**81 SOUTH CEDAR CREST
MAJOR PLAN 2023-107**

TO: PLANNING COMMISSION
FROM: GREGG R. ADAMS, PLANNER
SUBJECT: 81 SOUTH CEDAR CREST
MAJOR PLAN 2023-107
REQUEST FOR SKETCH PLAN REVIEW

SUBJECT: South Whitehall Township
81 South Cedar Crest
Major Plan #2023-107
Sketch Plan Review

REVIEW COMMENTS

CONCEPTUAL PLAN

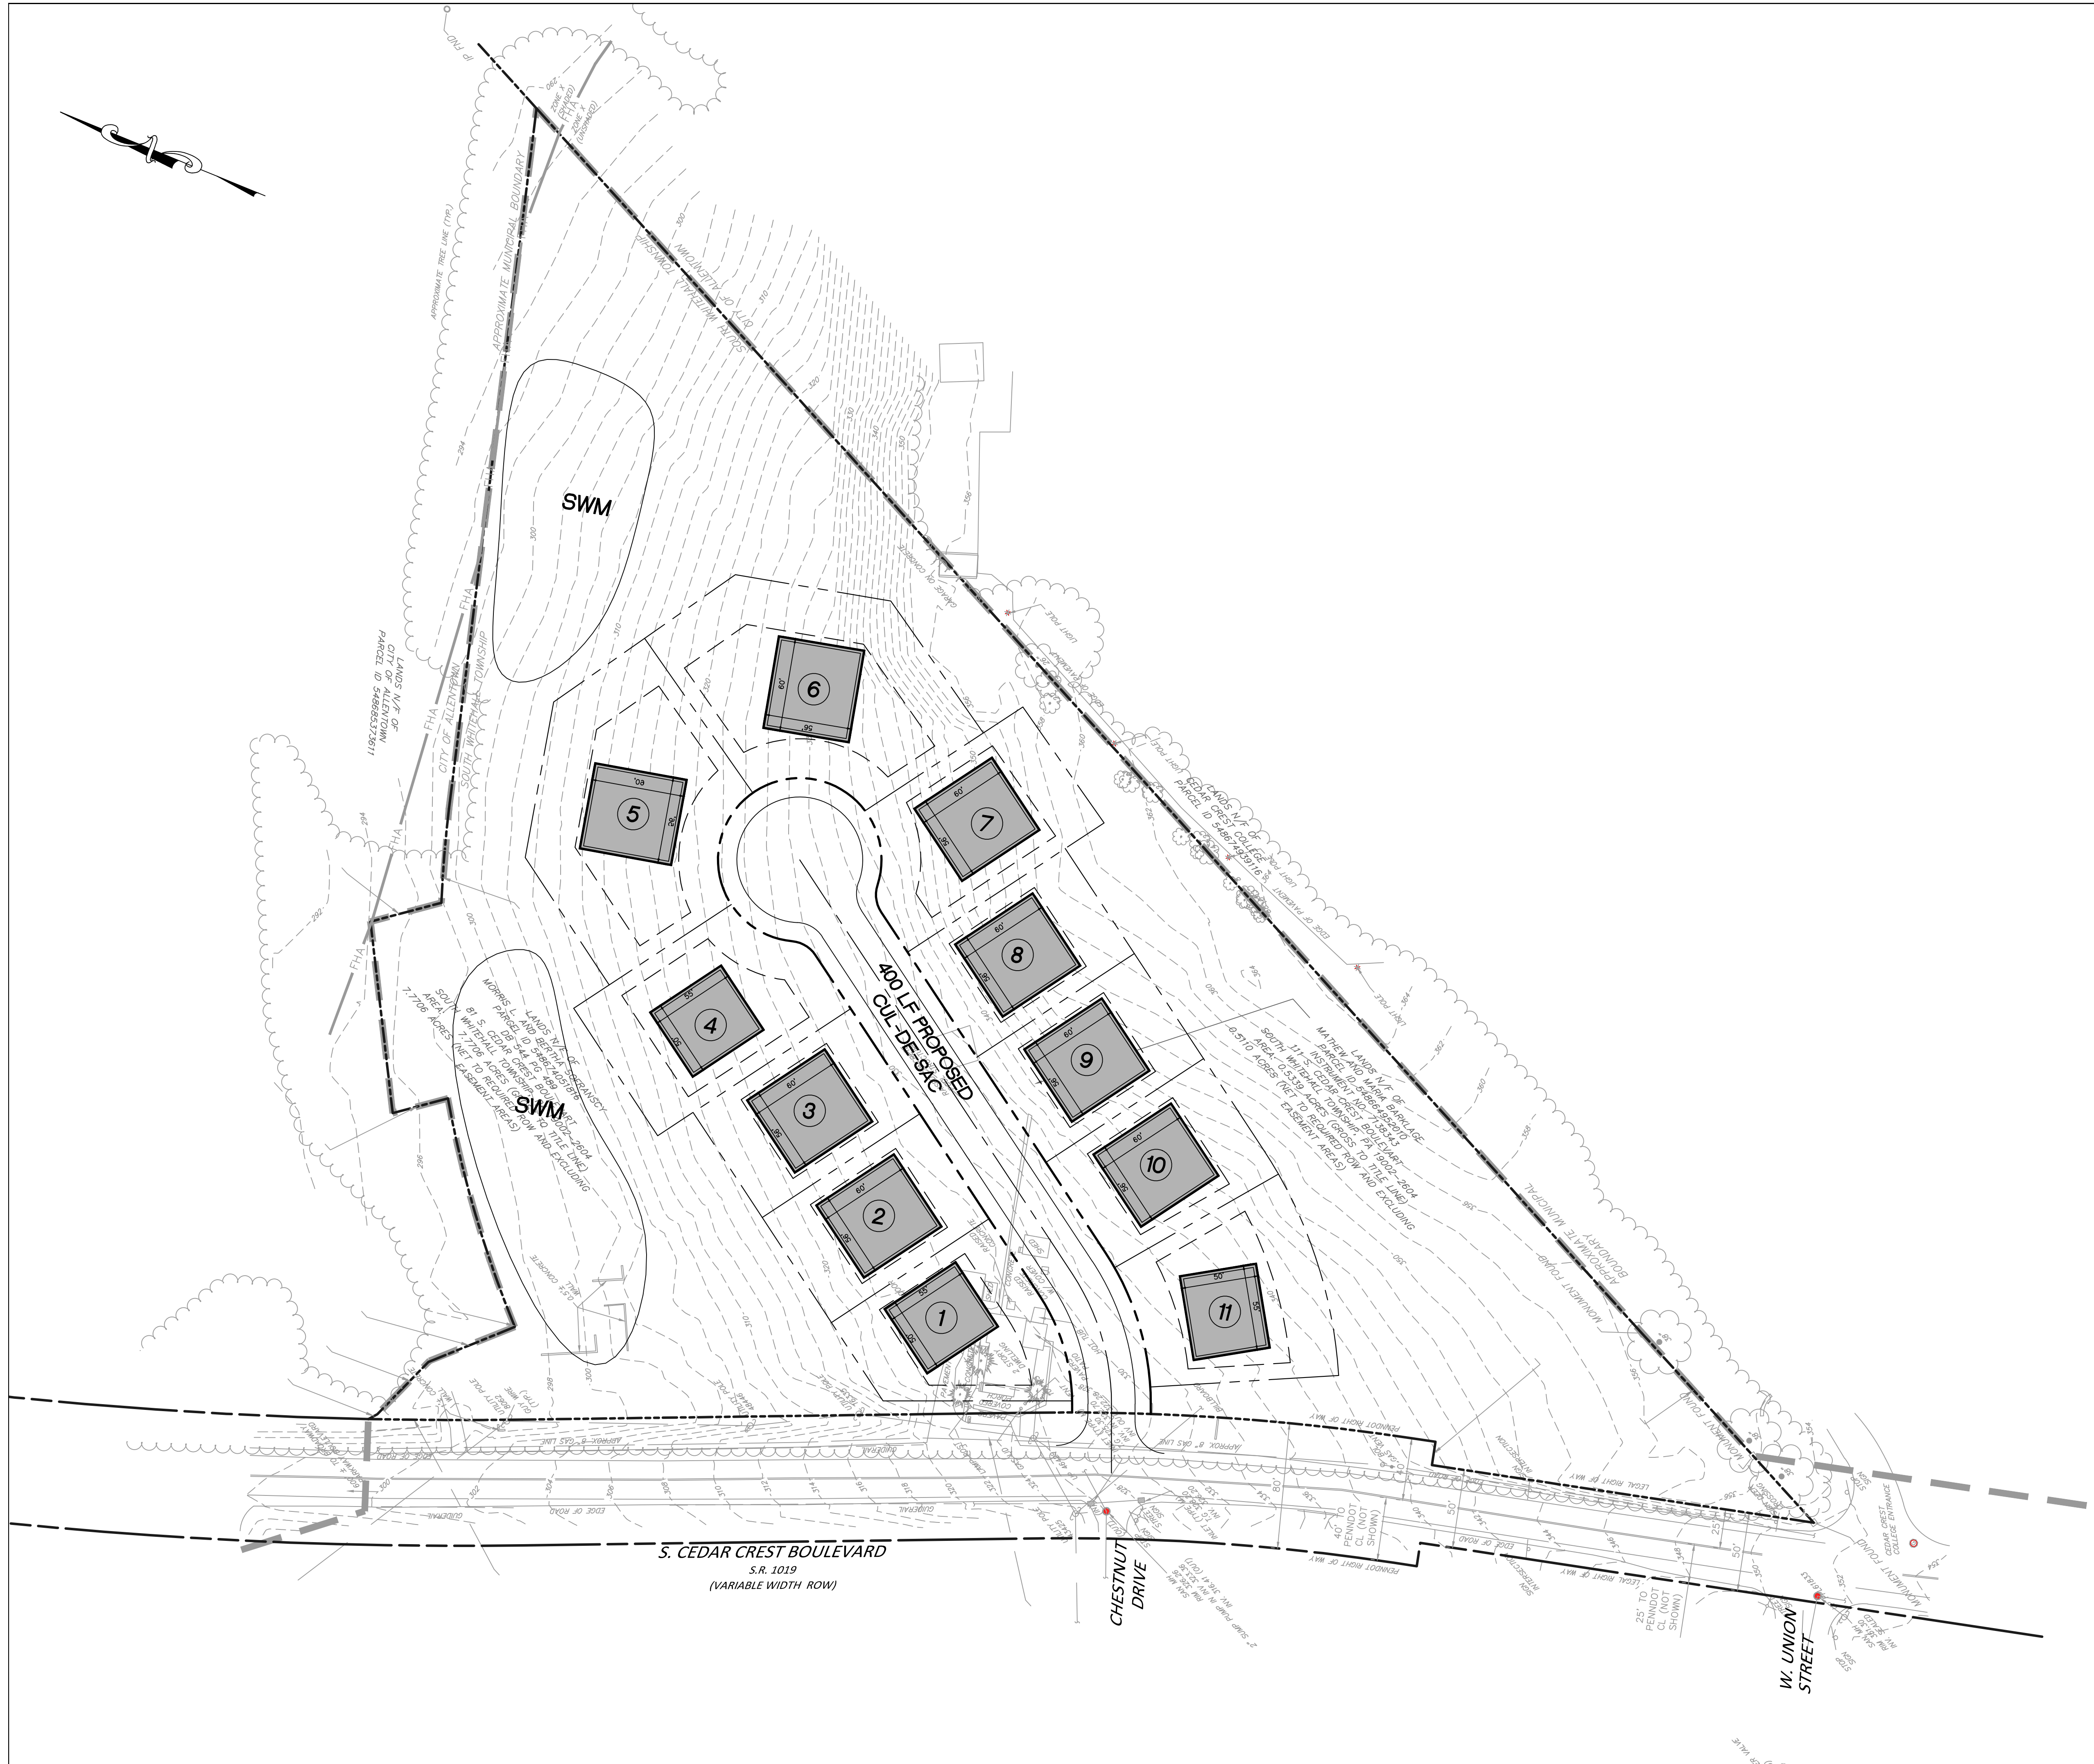
1. The project is located in the Little Lehigh Creek Watershed Act 167 Subareas 192 and 199 which are 30/50 and 30/100 percent release rate districts respectively. Stormwater management system plans and design calculations which demonstrate that the proposed development will meet the Act 167 runoff requirements and the water quality volume (WQv) requirements for discharge to any contiguous properties for each discharge point should be submitted for review with the Preliminary Plan. It should be noted that the Little Lehigh Creek Act 167 lists several Significant Obstructions (Nos. 152 through 155) downstream of the site;

2. The following improvements along the property frontage are required along Cedar Crest Boulevard and the proposed cul-de-sac per the SALDO: right-of-way dedication, cartway widening, curb, sidewalk, monuments, shade trees, etc. (SALDO §312-26(a) §312-35(b), §312-36, and §312-40 pertain), and should be shown on the Plans. Per ZO §350-42(t), show the ultimate right-of-way along Cedar Crest Boulevard 50 feet from the centerline. Any improvements along Cedar Crest Boulevard and the proposed intersection to the site are to be reviewed and permitted by PennDOT;

3. Provide floodplain mapping per FEMA and obtain any applicable permits for work within the existing floodplain, SALDO §312-10(b)(14);
4. We recommend investigating a connection to the Cedar Creek Path to provide pedestrian connectivity from Cedar Crest College to the Park;

5. Provide truck turning templates (trash, fire, and delivery) for the site as part of the Preliminary Plan submission to demonstrate the roadway radii are adequate to handle trucks entering and exiting the site without impeding oncoming traffic. In addition, truck turning templates should be provided demonstrating the ability of trucks to maneuver through the site;

6. Address the following Sketch Plan related comments:
 - a. Provide a signed statement that the applicant is the owner, or authorized by the owner to make an application for the land should be provided on the Plan, SALDO §312-10(b)(4);

- b. Expand the Zoning Data Table to include the area in square feet or acres for each lot, the linear feet of new road, impervious cover, and driveway separation measurements SALDO §312-10(b)(5)(B), §312-10(b)(5)(C), and §312-10(b)(5)(H);

- c. For clarity, label the site, identify the floodplain, and clarify the street names on the Location Map, SALDO §312-10(b)(6);
 - d. Dimension the front, side, and rear yard setbacks and proposed right-of-way, SALDO §312-10(b)(9). It appears that Lots 1 and 11 may be corner lots and have 2 front yard setbacks;

- e. Provide property boundary information within the site and within 200 feet of the site, SALDO §312-10(b)(10). We note that the Barklage lot line information is not clear;

- f. Show any proposed staging, SALDO §312-10(b)(11);
 - g. Identify significant physical and topographical features including the floodplain and its basis, (e.g., Panel 42077C0234F, revised July 16, 2004), wetlands, water conservation areas, steep slopes, and woodlands, SALDO §312-10(b)(12);

- j. Identify the intended use or removal of any existing facilities (e.g., existing dwelling, existing billboard, etc.) in the narrative and on the plans, SALDO §312-10(b)(14);

- l. Consider providing buffering/screening of the existing Cedar Crest College parking area/facilities to the east, SALDO §312-10(b)(14) and ZO §350-42(b).

7. We note the following as it relates to the proposed cul-de-sac:
- a. Although the proposed cul-de-sac does not meet the required 800-foot offset along Cedar Crest Boulevard from Union Street, SALDO §312-35(a)(6)(E)(i), its centerline will align with existing Chestnut Street (directly opposite Cedar Crest Boulevard). A waiver from this requirement may be necessary;

- b. Revise the cul-de-sac to meet all Township Local Street Standards (e.g., 60-foot right-of-way required (50-foot proposed), 36-foot cartway required (30-foot proposed), curbing (none proposed), sidewalk (none proposed), street trees (none proposed), etc.), SALDO §312-35(b)(3)(D);

- c. Revise the design of the cul-de-sac to provide a 100-foot tangent between the curve and the street intersection (50-feet± provided), SALDO §312-35(b)(3)(A)(v);

- d. Provide a snow drop off area per SALDO §312-35(b)(2)(B)(iii);
 - e. Required and available sight distances and lines based on PennDOT intersection sight distances as well as the Township Clear Sight Triangles should be provided on the Preliminary Plans, SALDO §312-35(a)(6)(F). The required sight distances should be depicted using sight lines and the available sight distances should be labeled on the plans;

- f. Identify driveway locations to confirm driveway offsets are met per SALDO §312-36(c)(4)(A);
 - g. Add a note subsequently to the Preliminary Plans indicating that lots which contain frontage on Cedar Crest Boulevard and to the proposed cul-de-sac should take access from the interior roadway, SALDO §312-36(b)(5); and
